# Feasibility Report into the required improvements at the crossing of

## A2203 Blackwall Lane by Tunnel Avenue

### TFL Signal Ref: 06/248

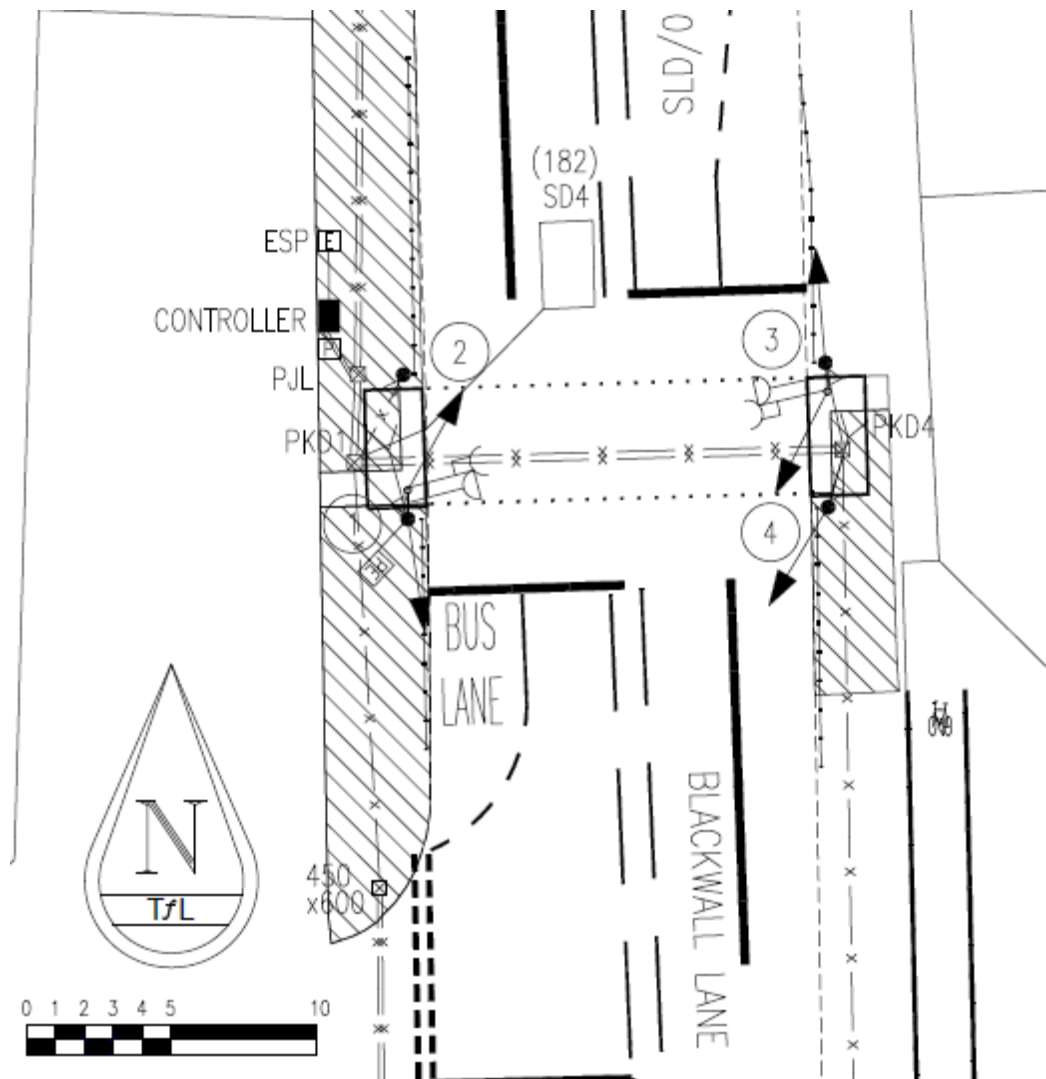
Despite the level and straight section of road on which this crossing sits the visibility of the signal, even without traffic blocking the approaches is less than adequate, as can be seen in the picture above.

The crossing has dual lane (one bus lane and one general traffic lane) approaches in both directions, however the Southbound has two traffic signal heads and the north bound three. When high sided traffic is present, some or all of these signal heads are blocked to other approaching vehicles.

If a bus were to be waiting at the bus stop on the south bound approach the prominence of the crossing would be almost non-existent to other vehicles.

Despite the fact that this is a stand along crossing it does not have zig-zag markings. It has been a requirement for these marking to be in place at all stand-alone crossings since the beginning of 2007. In the time since then and now this site has been modified and should have been rectified by now.

First of all the crossing needs to have zig-zag markings installed. It is not acceptable for this to be left non-compliant more than a decade after the deadline to add these markings to stand-alone toucan crossings.

Secondly the prominence of the traffic signal heads needs to be greatly improved. Simply adding an additional secondary signal or offsetting a pole would not be sufficient as this would be just another signal head blocked by buses / high sided vehicles.

1. Install a centre island and mount poles and head in the middle of the crossing.
2. Install a mast arm with associated additional signal heads.
3. Install 6m poles on the crossing and add to the signals with high level aspects.
